Chapin Ave. Burlingame

March 27 2025 Planning Commission Study Session Comments & Responses

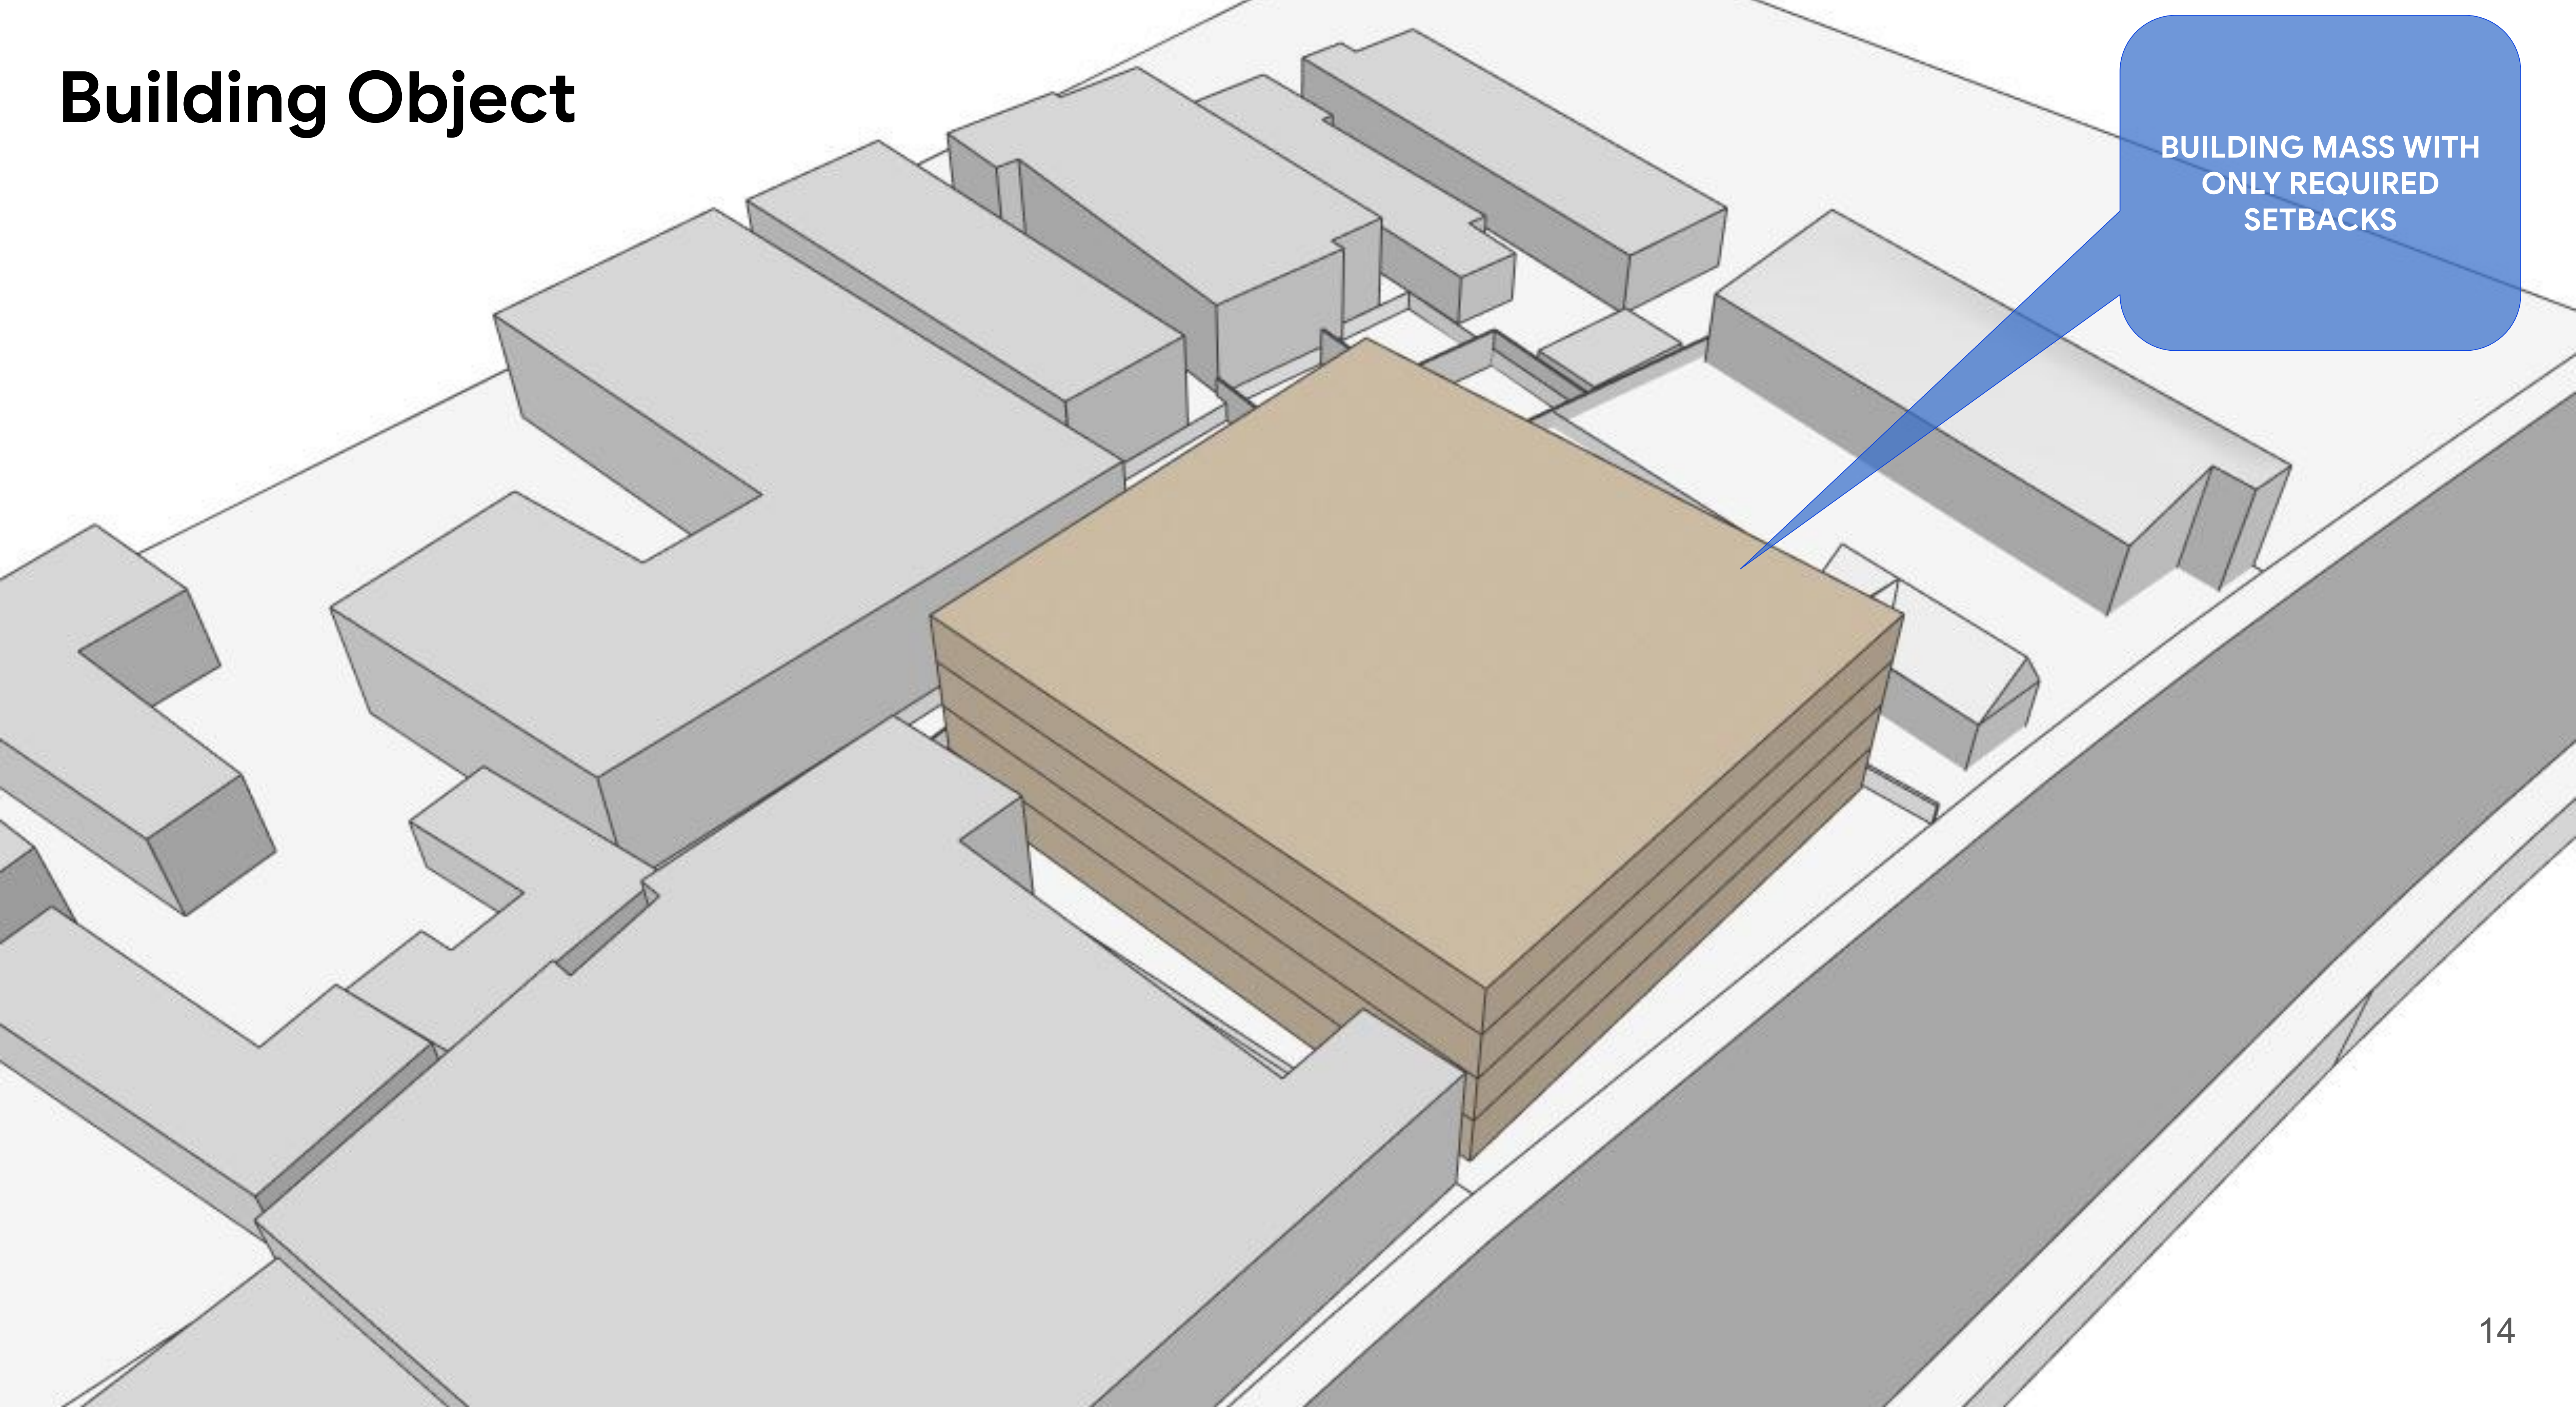
Address the massing and scale. Okay with the taller height on Chapin Avenue but building needs more architectural detailing to break up the massing.

Variable massing is a core principle of this design. From the outset, the building was purposefully conceived to break down its scale and avoid the “square box” appearance that often results from maximizing every allowable setback.

A series of setbacks, atriums, and articulations create architectural relief, reduce perceived height, and add visual variety. Portions of the project are experienced at 0’, 20’, 35’, 55’, and 75’ heights, producing a dynamic, layered profile that softens its overall scale.

At the pedestrian level, the Chapin Avenue frontage is tiered to read as a two- to three-story building, while the upper floors are stepped back to minimize their visibility from the street. Large internal atriums bring light and air deep into the building, functioning as park-like environments within the workspace.

Side Balconies | Architectural Feature

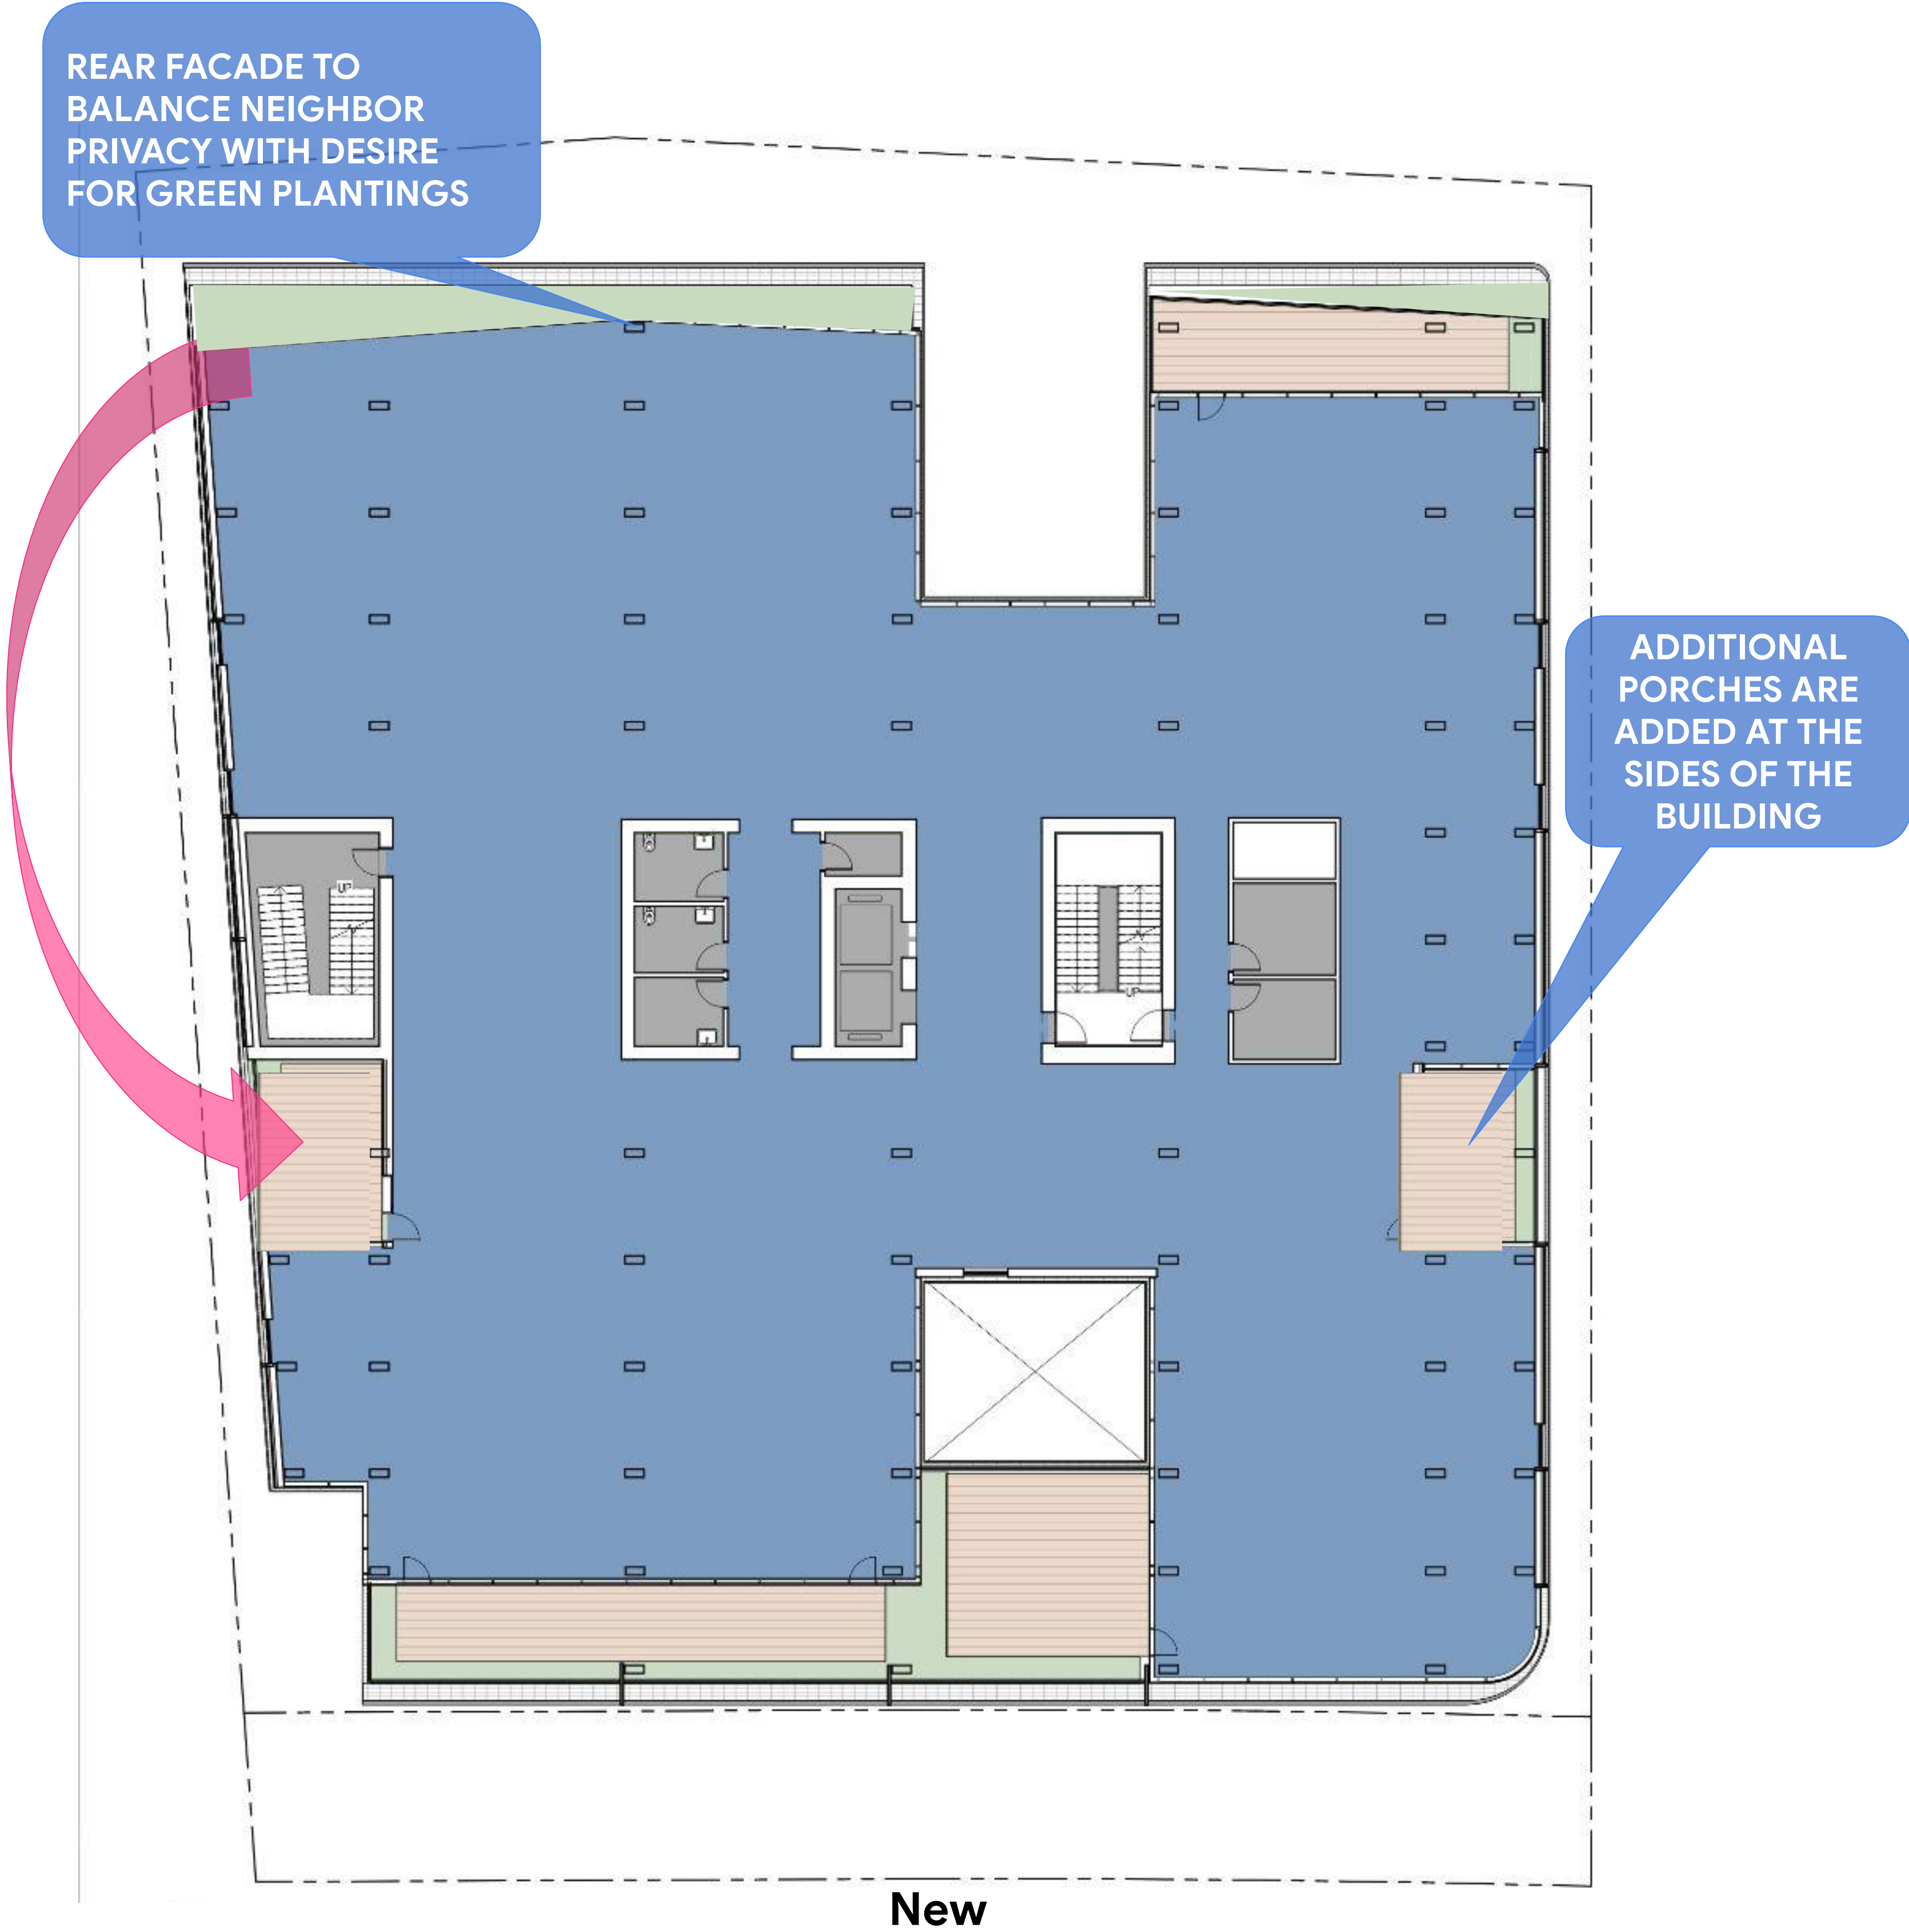
Consider a more tiered design approach on the sides to respect the neighbors.

The design team has incorporated the Commission's feedback by introducing additional tiering, cut-outs, and balcony elements along the side elevations to create visual interest and massing relief for the east and west neighbors.
